Re: **LETTER OF TRANSMITTAL
ROOMS TO GO STORE EXPANSION AND REMODEL**
18722 South Dixie Highway
Cutler Bay, FL 33157
ADDENDUM #3

ADDENDUM NO. THREE

POWER PLAN
E2.0

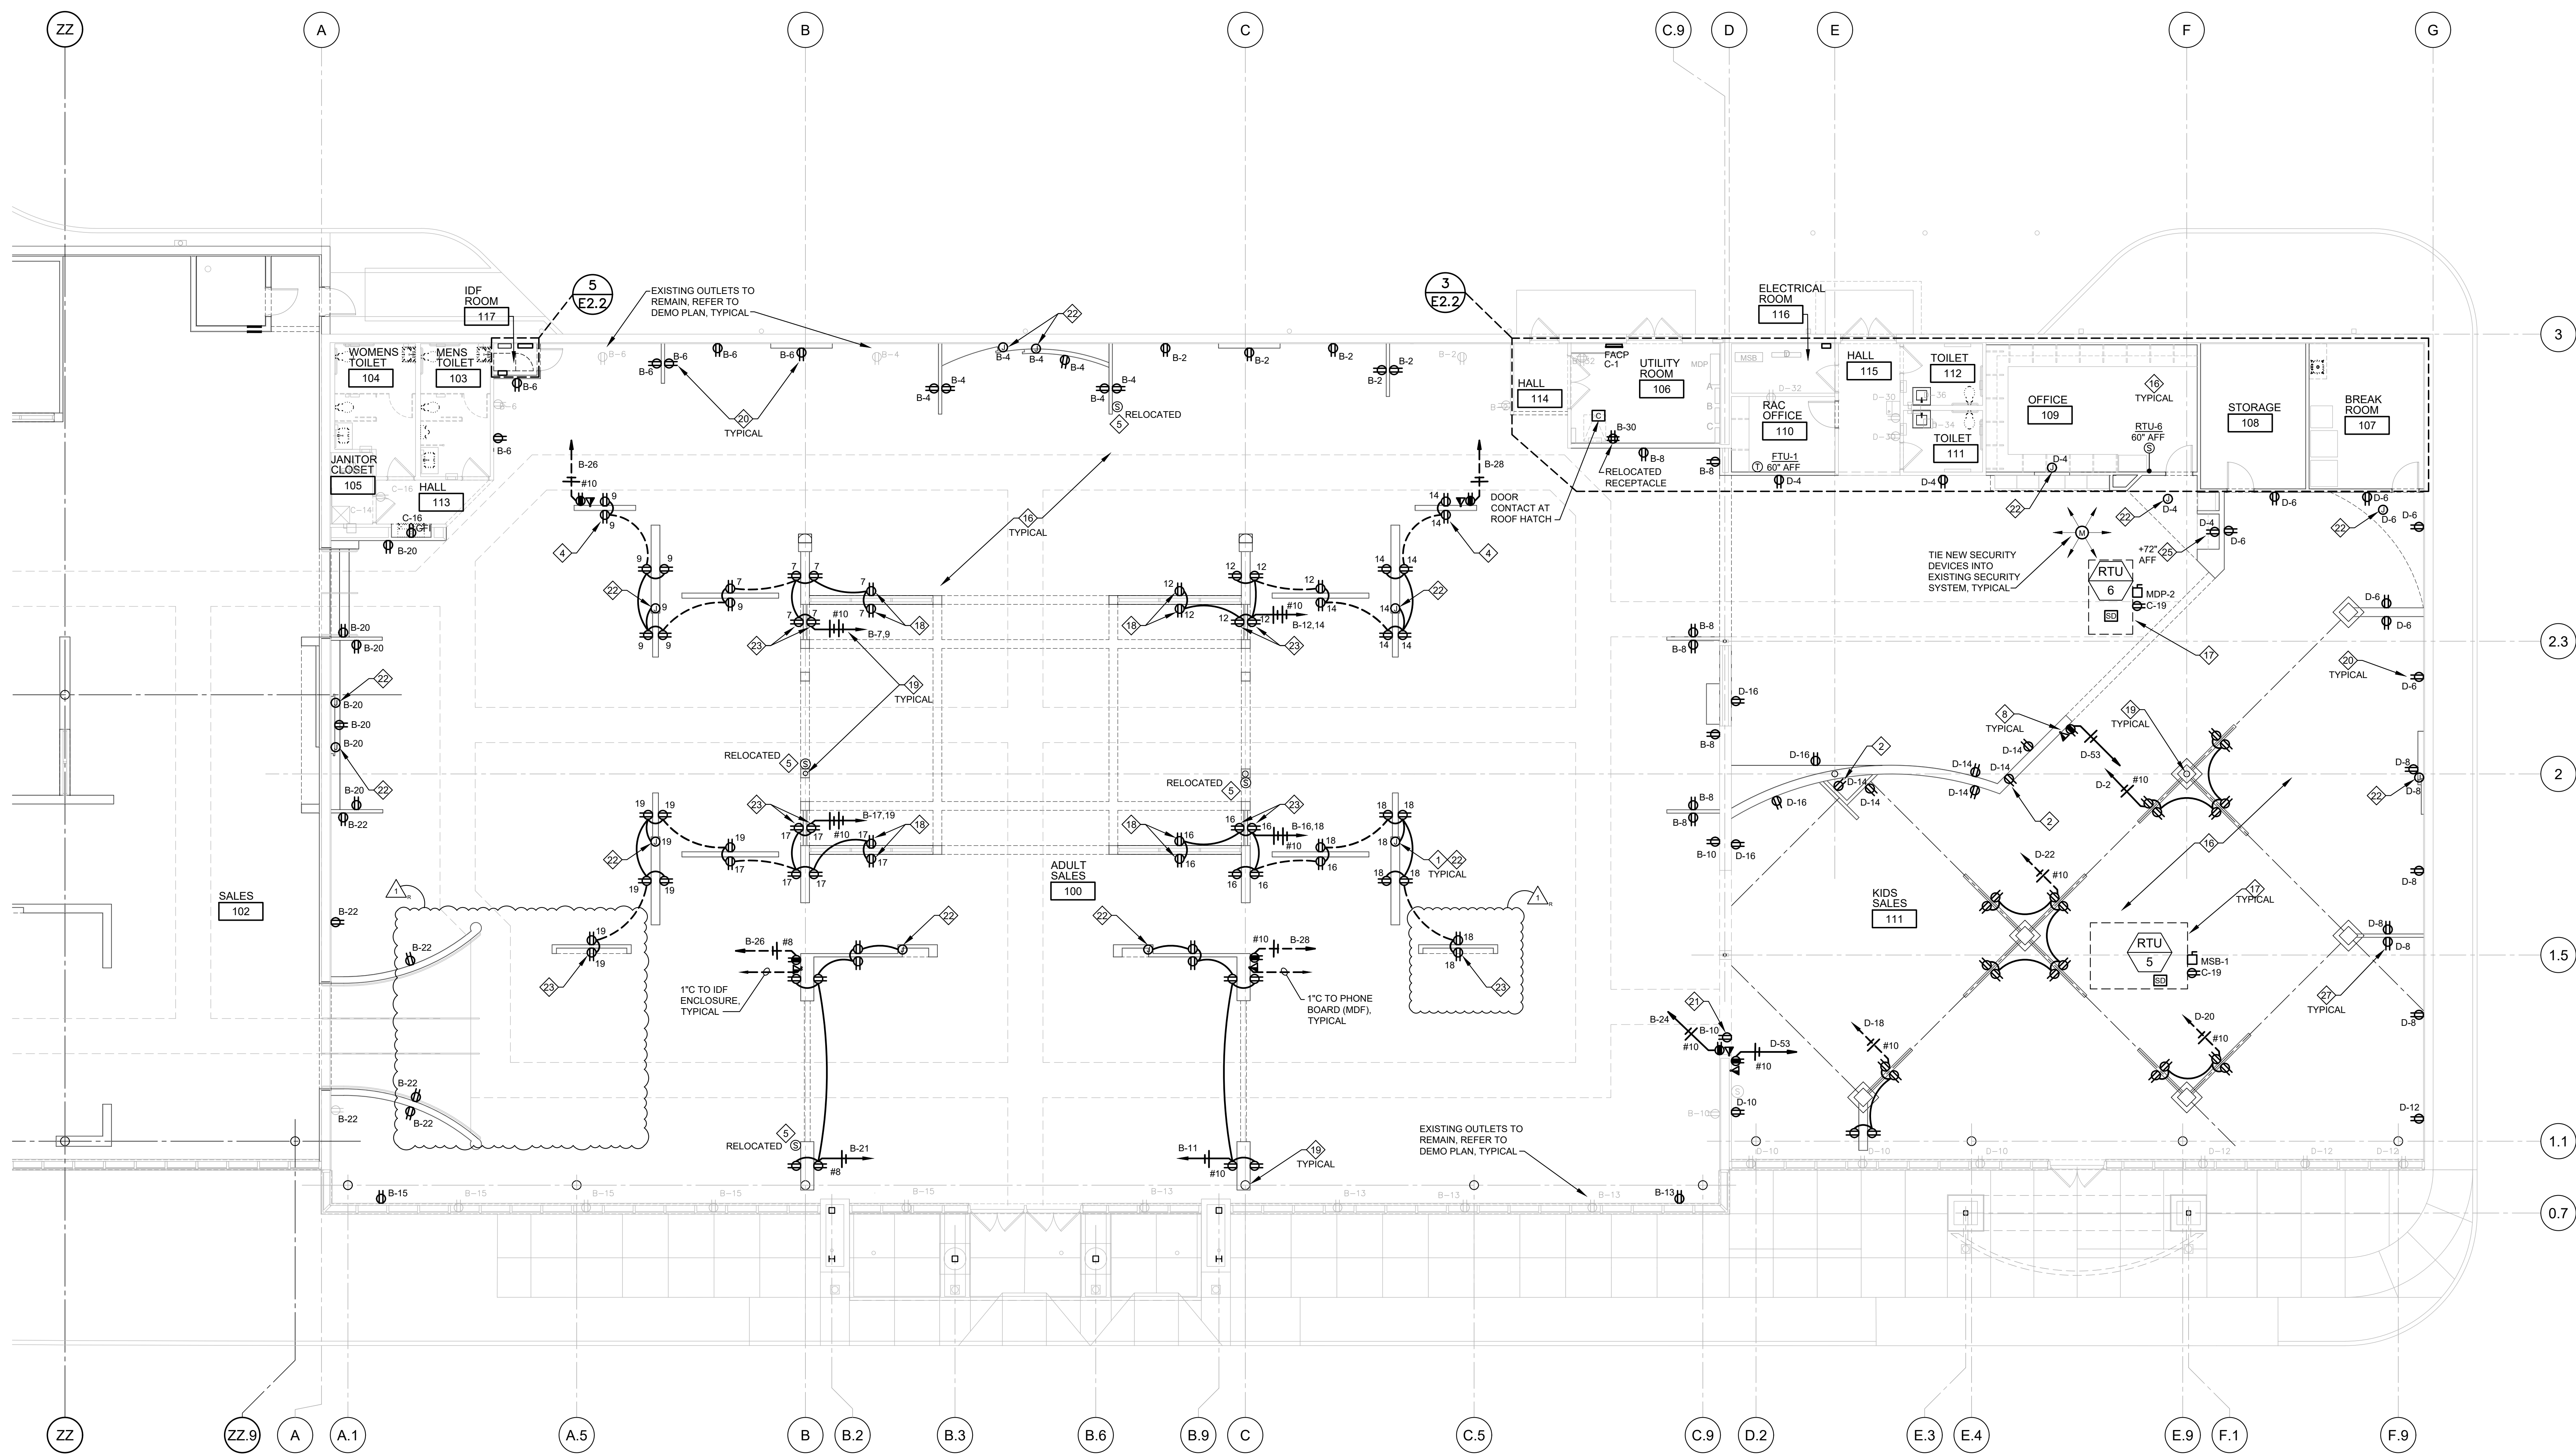
8. Sheet E2.1 – Revision No. 1: Revised interior elevation F layout and relocated receptacles accordingly (two locations). Added three receptacles at interior elevations O & O1 and added circuits from closest outlets.

1 LIGHTING PLAN
E3.0 SCALE: 1/8" = 1'-0"

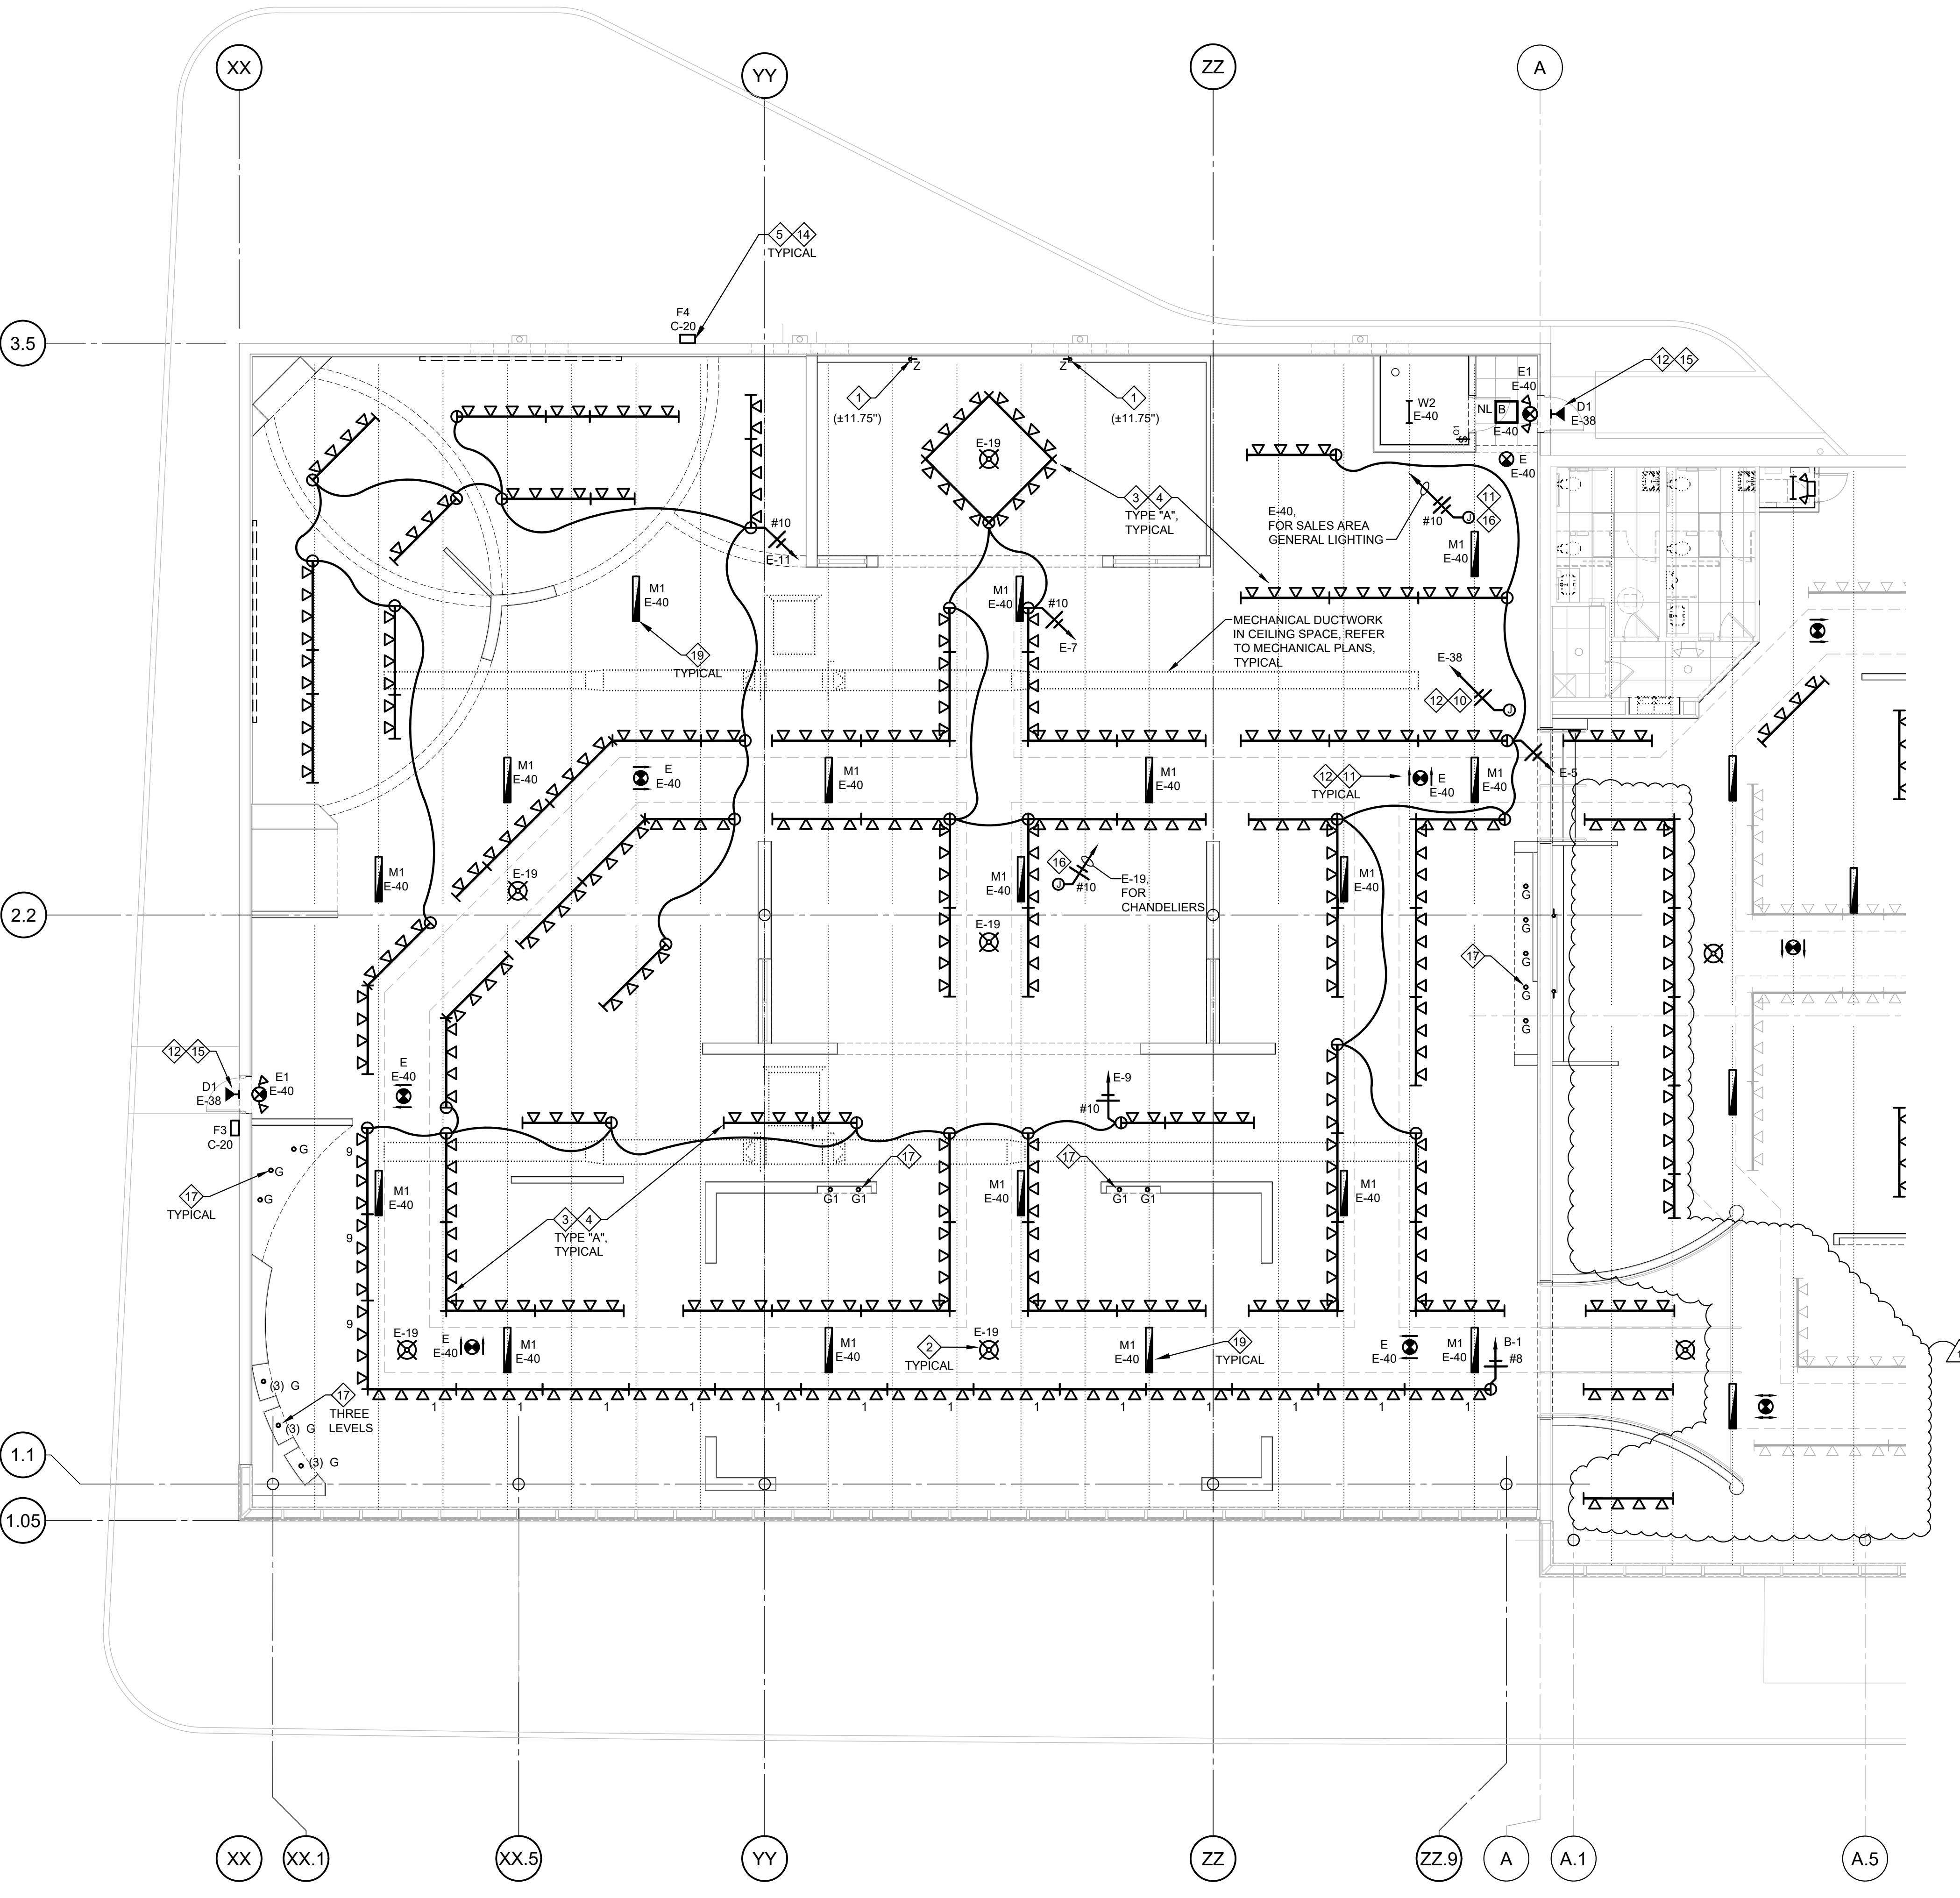
9. Sheet E3.0 – Revision No. 1: Revised track lighting layout in Adult Sales #100, close to expansion side.
10. Sheet E3.1 – Revision No. 1: Revised track lighting layout in Adult Sales #100, close to expansion side. Remove 4' of new track and two new track heads. Removed 8' of old track and 4 old track heads.
